WAIVER/CONCESSION

1. DOCUMENT IDENTIFICATION		1.1. Identification of customer: Rolls-Royce Canada Limited		Supplier #:		1.3. Document reference number Customer #: 210256950		1.5. Category: "GE-3656", CAT 2

2.1. Model of product/program: I TRENT		2.2. Part number: TRN14806		Drawing Issue:		2.4. Part Serial Number/Batch/Effectivity Number/Lot Number: (see box 3)		2.5. Quantity: 1	
Contract Number:		2.3. Part Description: CASE, INLET, ASSY OF		2.6. Product Number:		2.7. Work/Purchase Order Number:		2.8. Assembly Serial Number:

WAIVER/CONCESSION

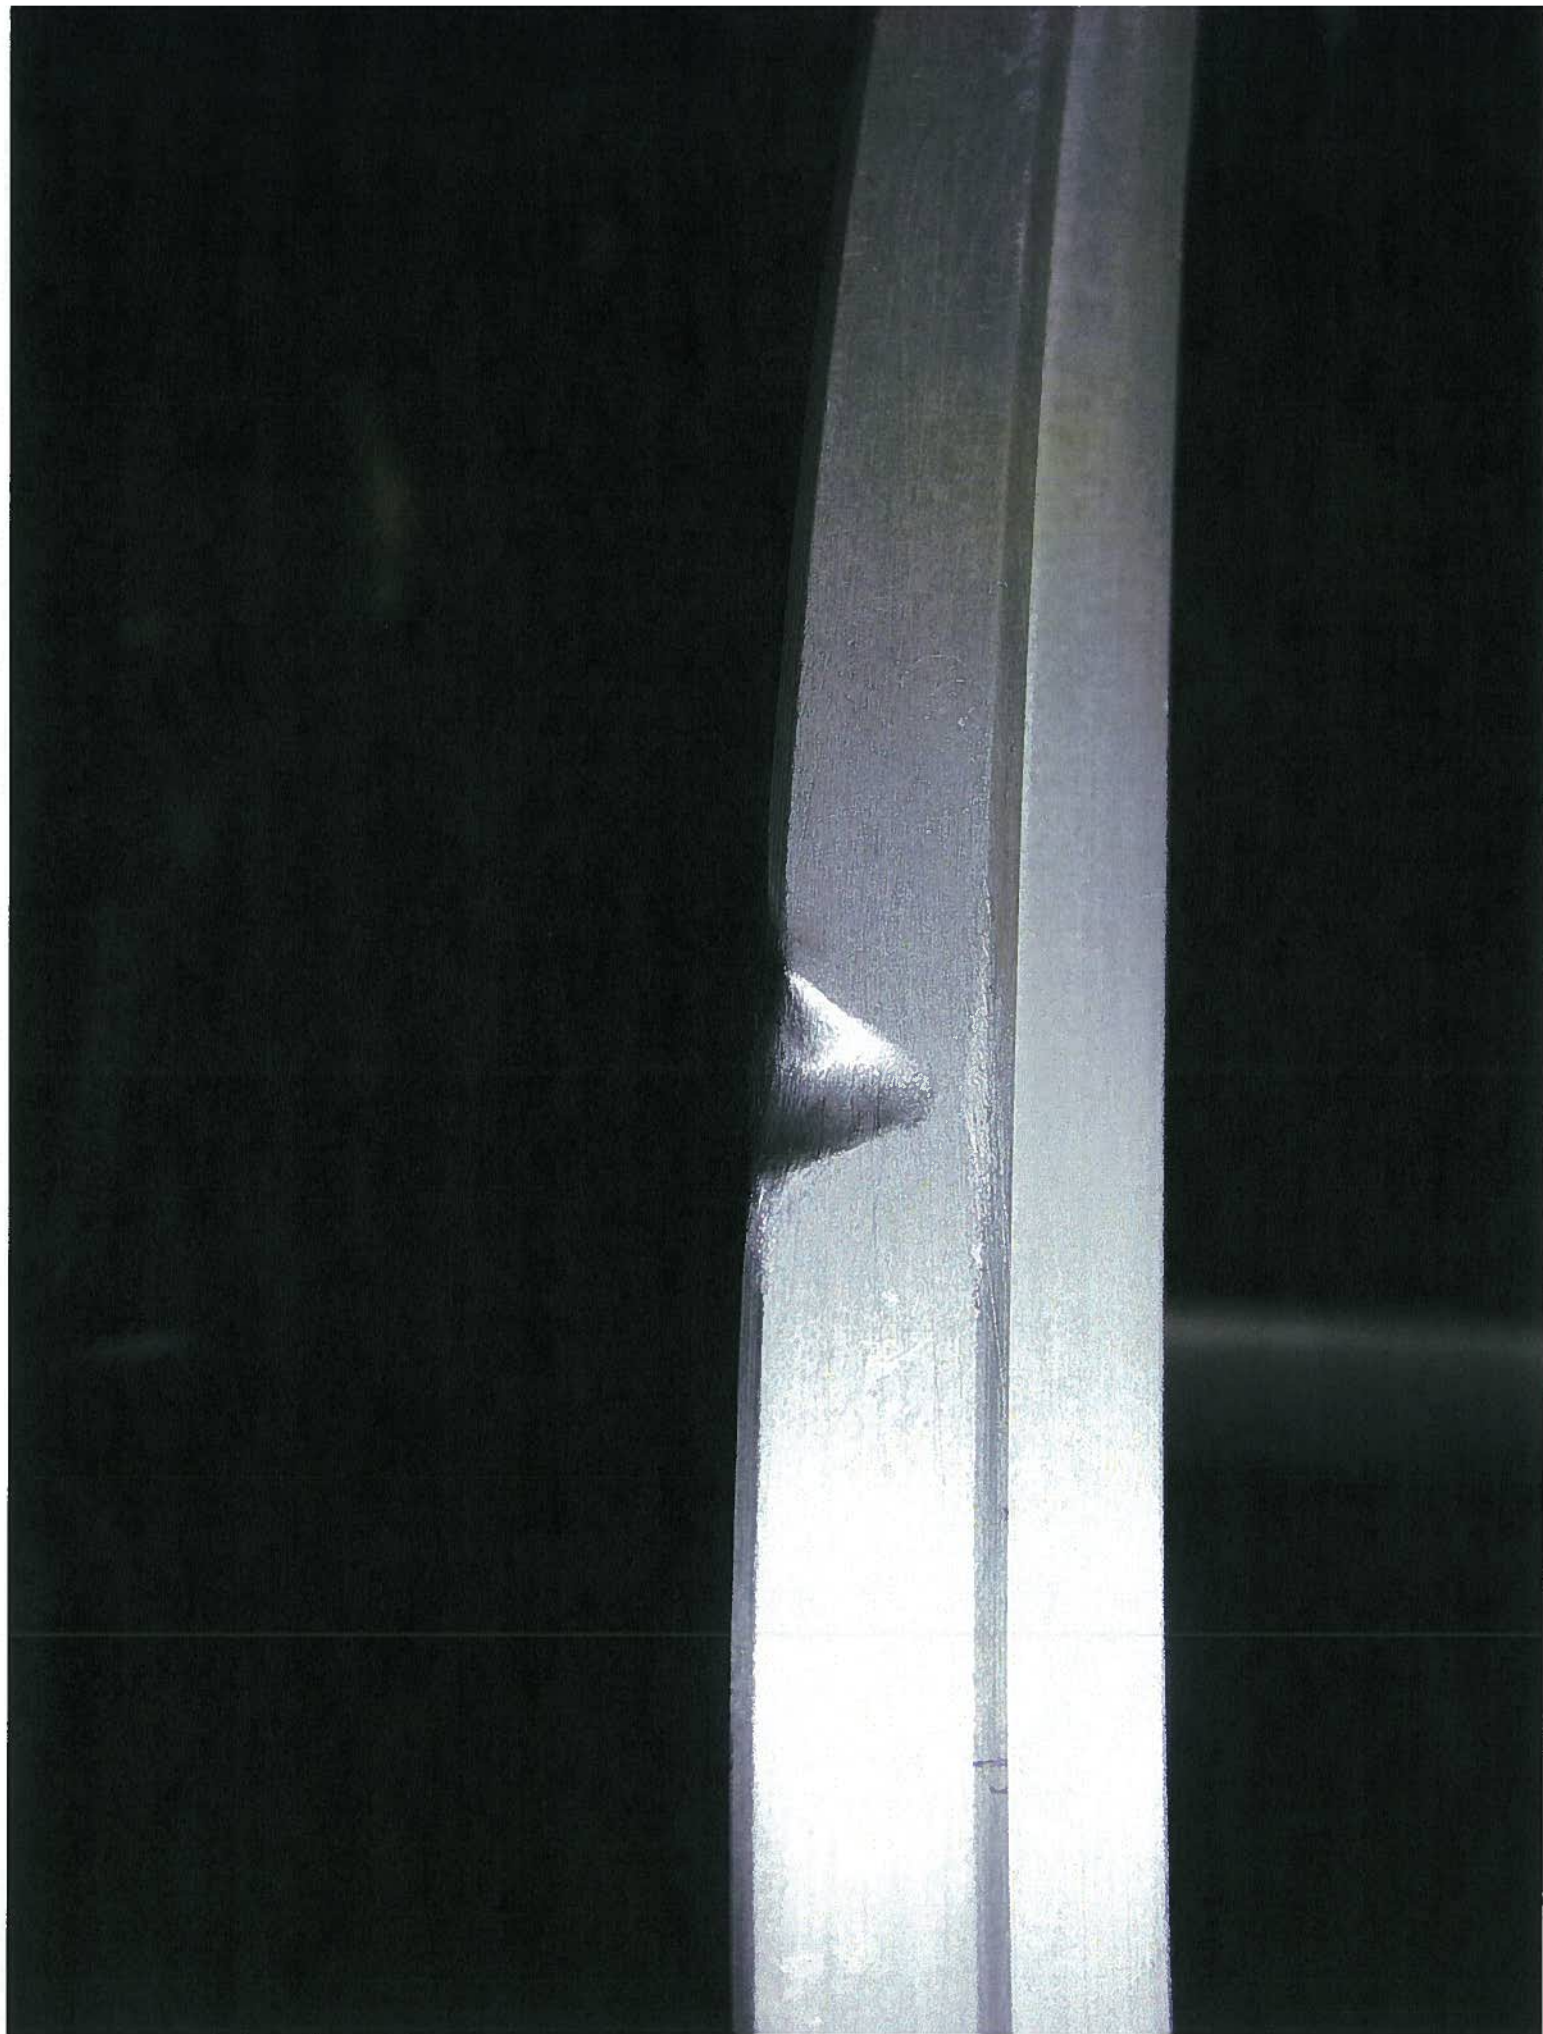
2.9. Assembly Drawing Number:	
3. DESCRIPTION OF NONCONFORMITY		5. DISPOSITION OF NONCONFORMITY							
Engine 056 Notification 210256989		5.1. MRB/Design Decision:							
The Inlet Case Assy was found damage on the external flange lip at BDC. Damage measures approximately 0.400in long by 0.360in wide by 0.240in deep. The damage occurred as the Engine was installed in the Transportation stand.		ACCEPTABLE CAT 2 FOLLOWING PROPOSED REPAIR. MARK "GE-3656" NEXT TO PART NUMBER.							
Request permission to polish and locally cracktest the damage as per scheme EFRS3253.		Quality Decision:							
Previous Submissions of a similar nature:		Previous Submissions to actual item:

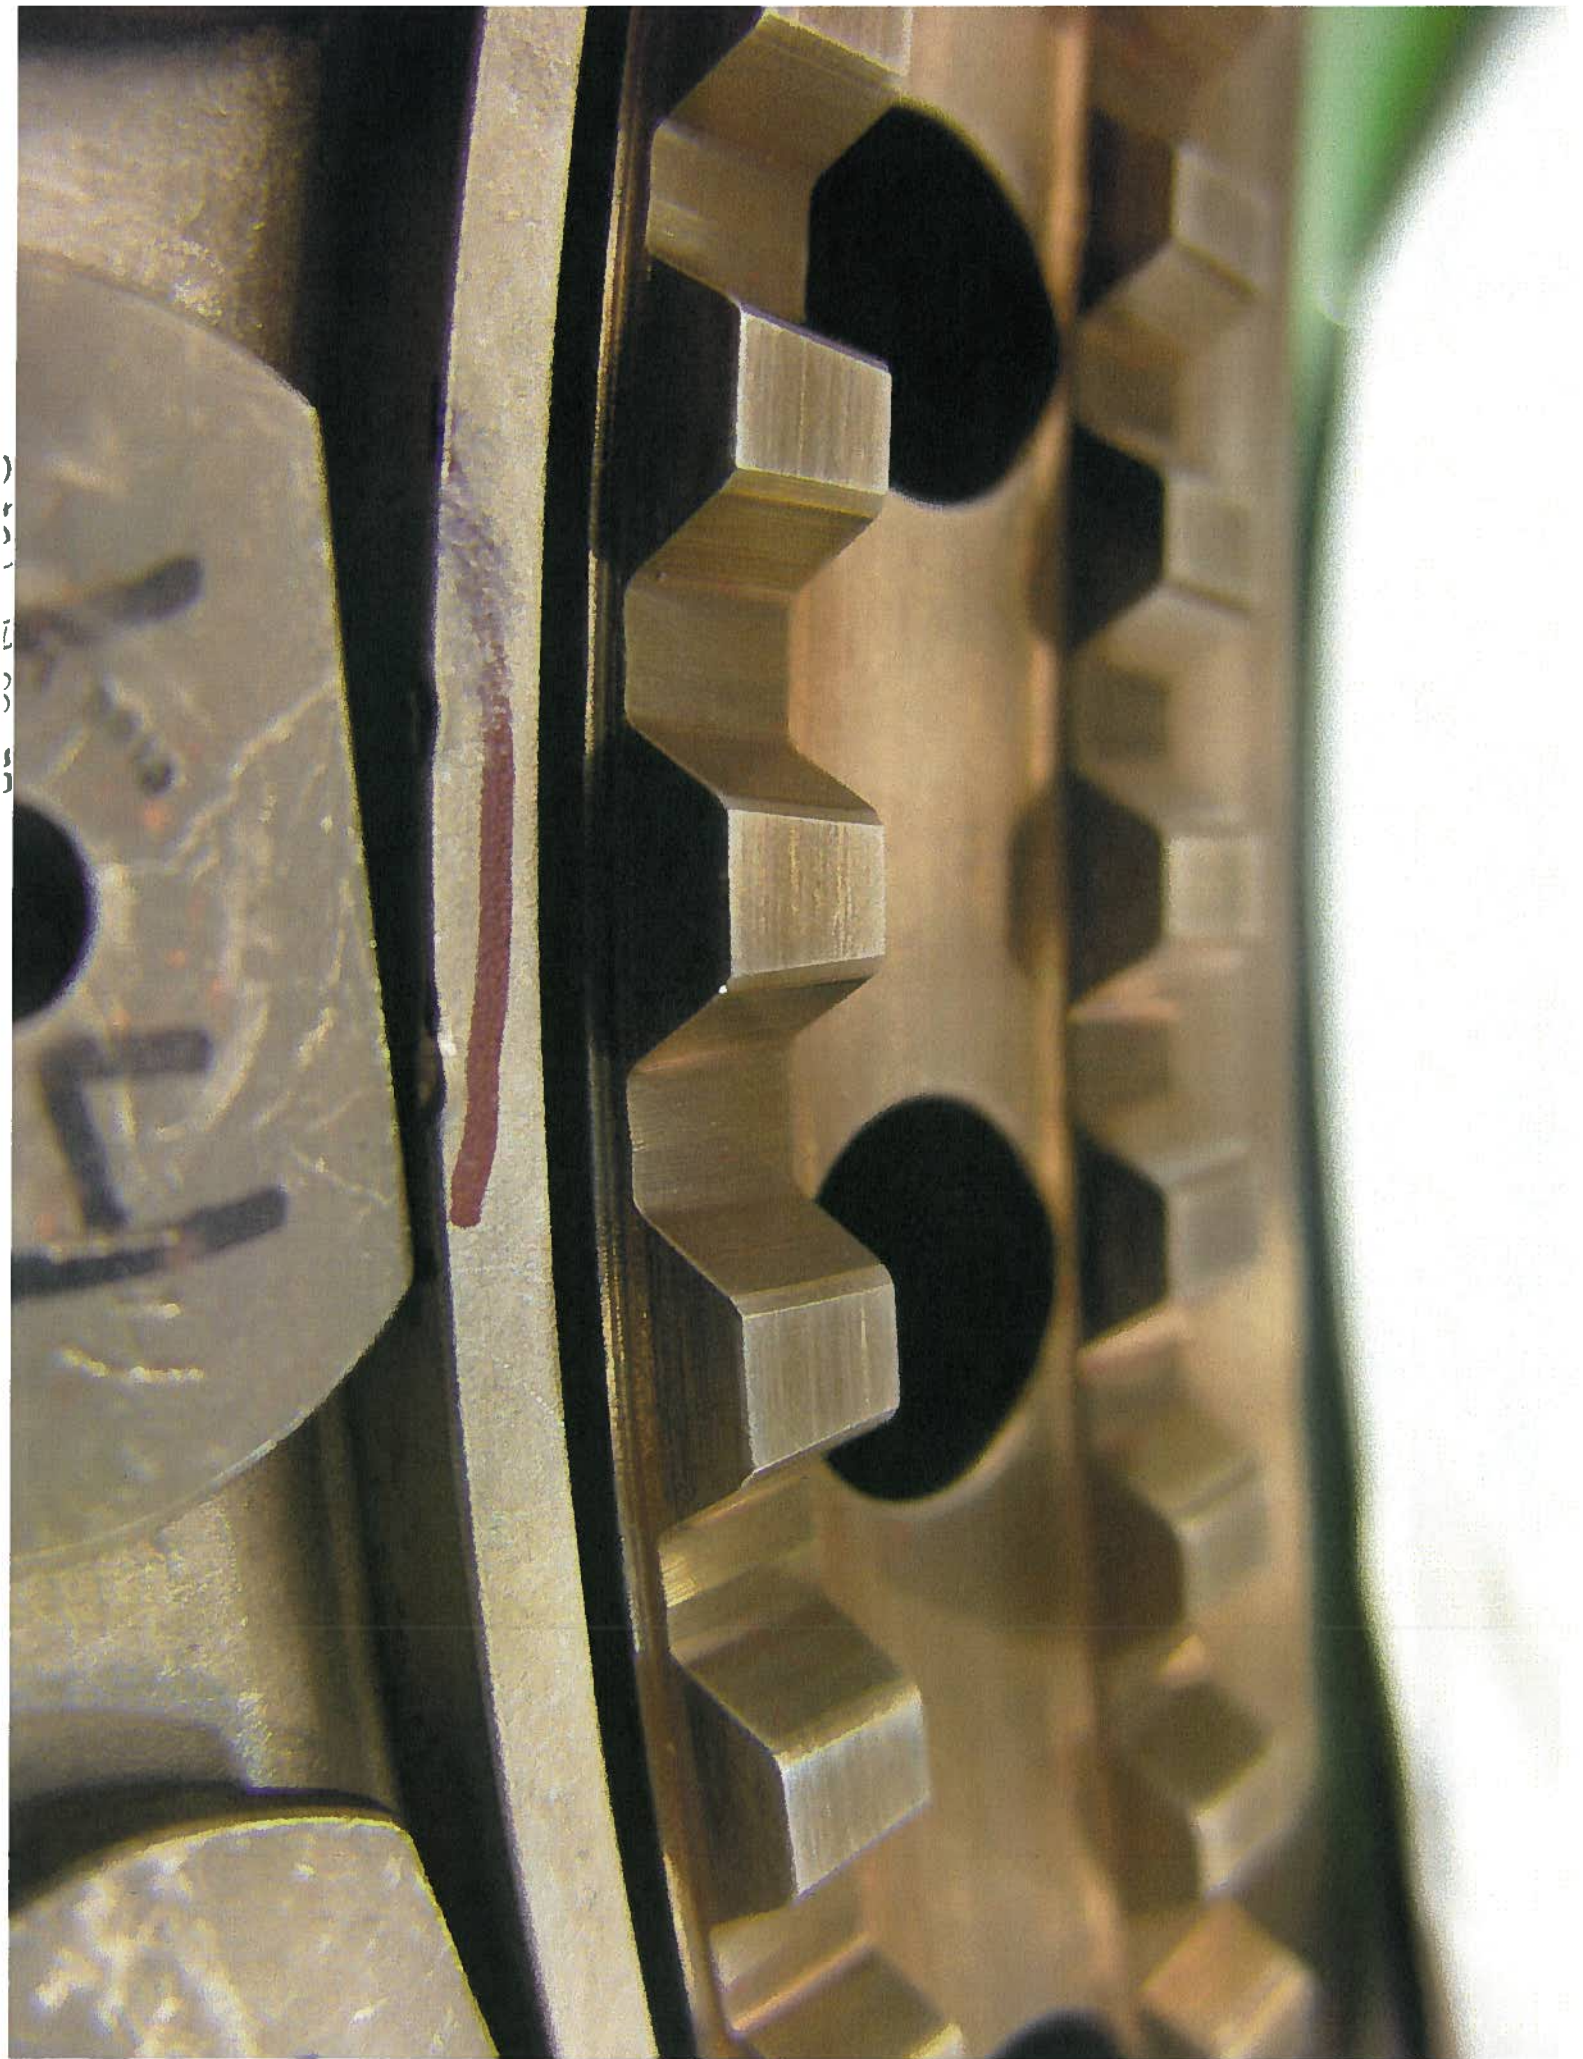
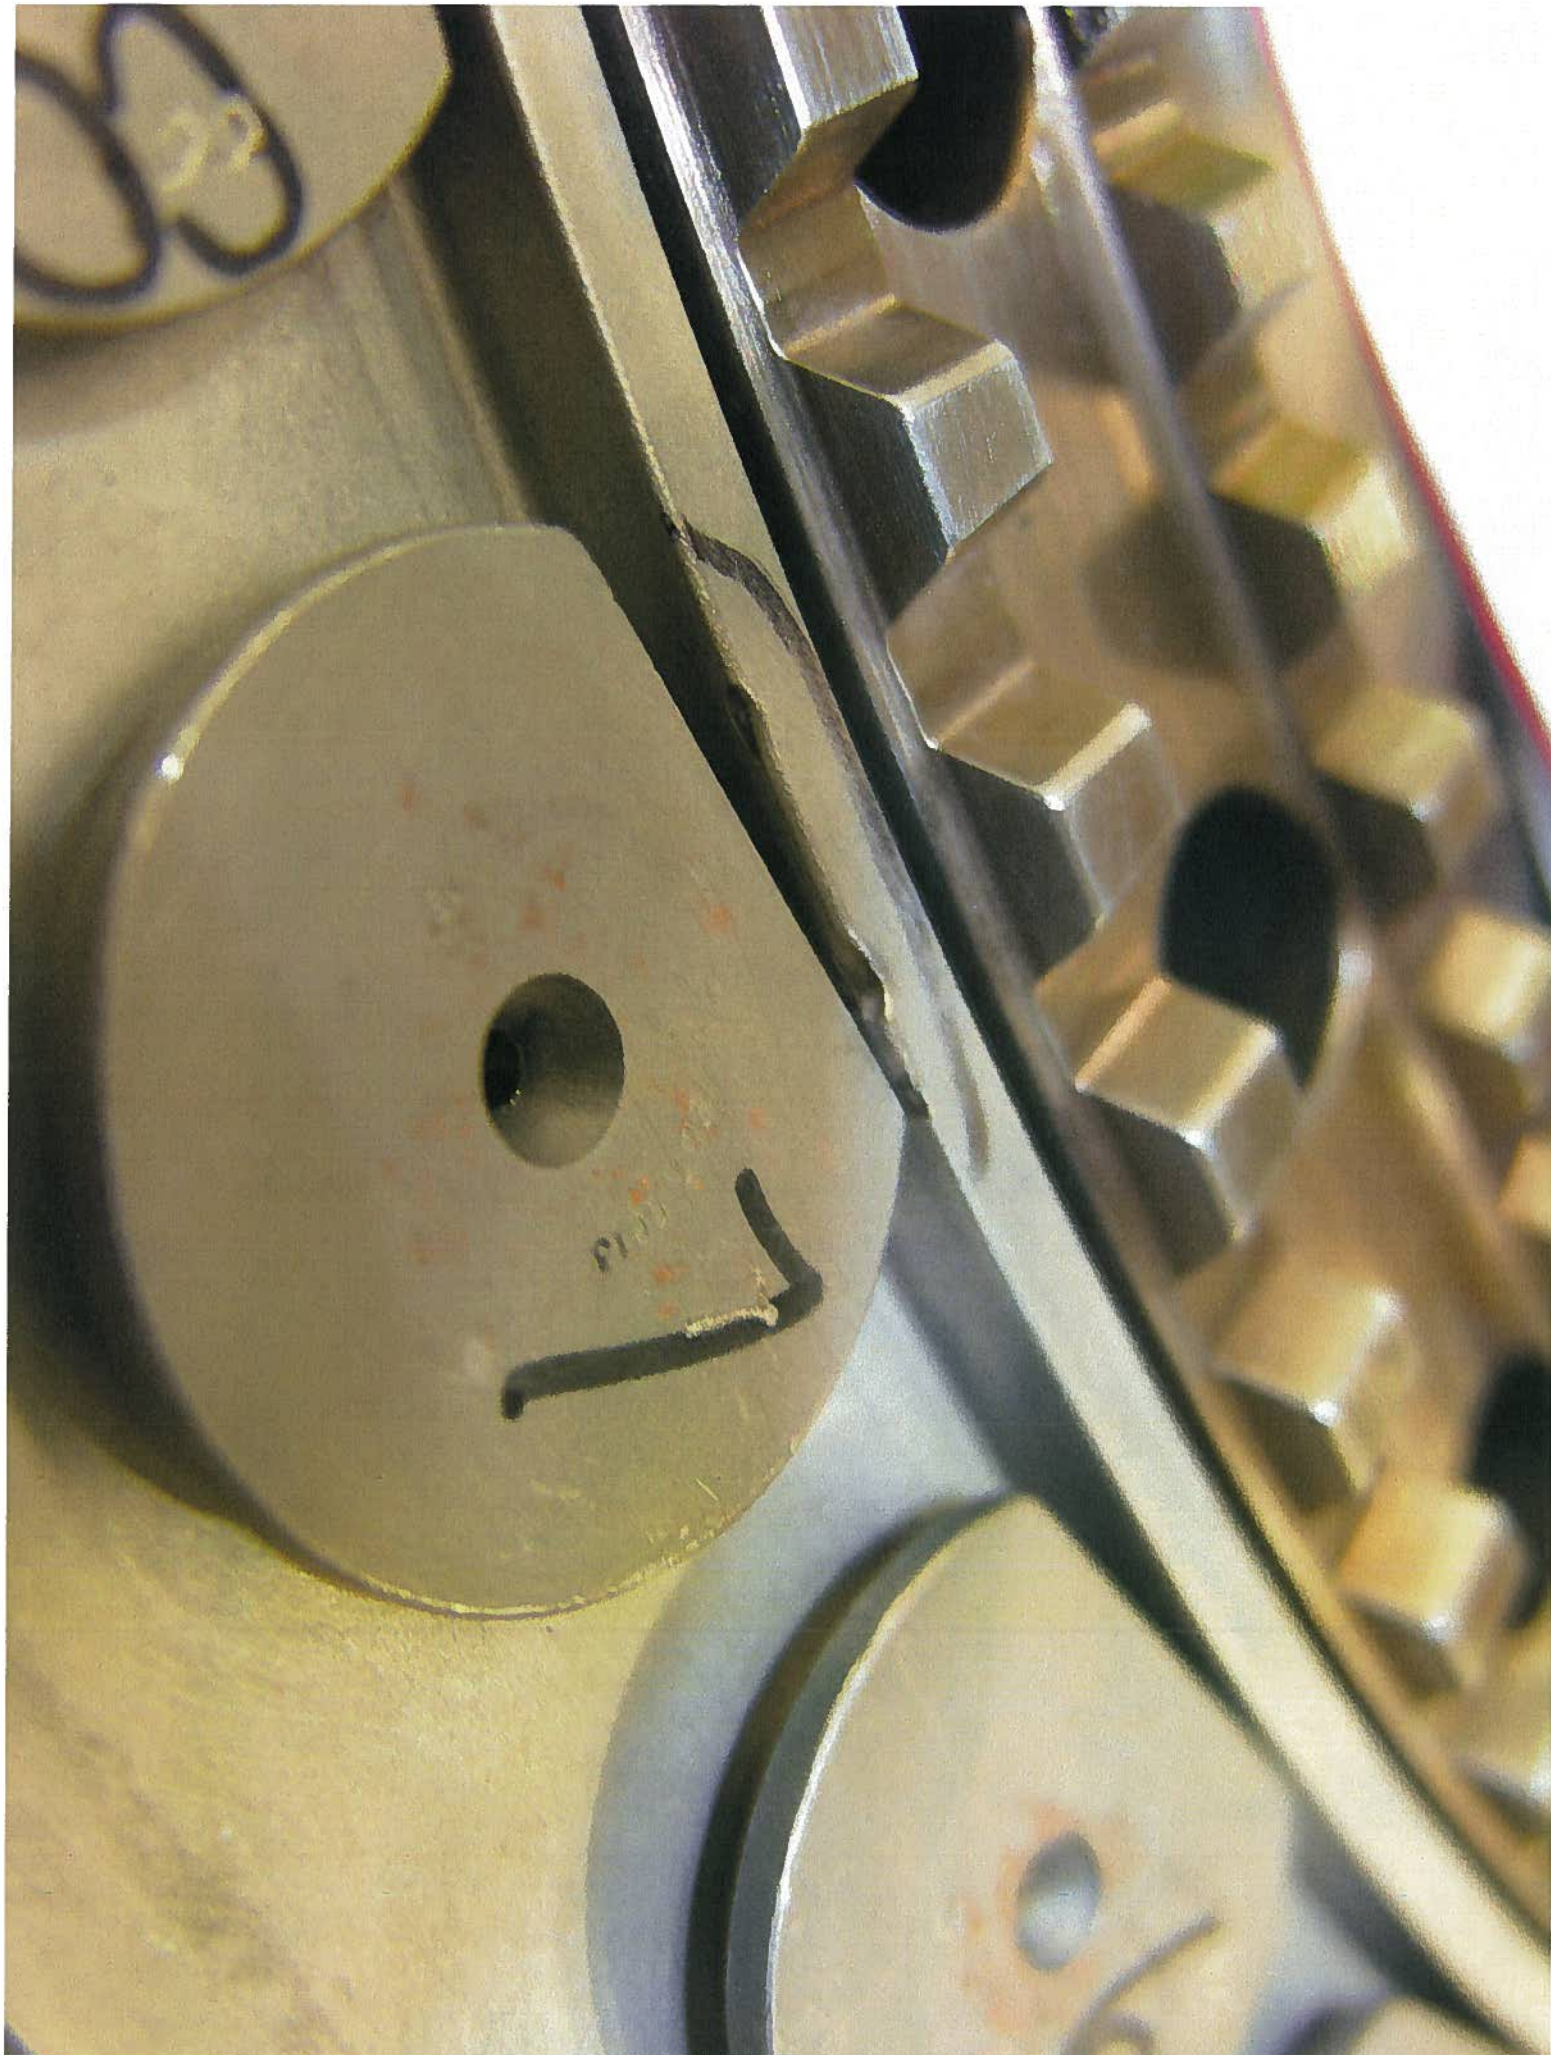
3. DESCRIPTION OF NONCONFORMITY		3.1. Detailed Description of the nonconformity							
IRENT ESN 056 Module08. Reference notification #210240551.		<p>During torque tightening of taper bolts, 3-off bolt head created nicks at adjacent abutment face corner. Front face of disc. Refer to attached pictures.</p> <p>Approx measurements: Between 0.082" long by 0.032" deep to 0.188" long by 0.038" deep</p> <p>Request to repair to remove evidence (dress out damage) as per EFRS6627 EFRS6625.</p> <p>Previous Submissions of a similar nature: Previous Submissions to actual item:</p>
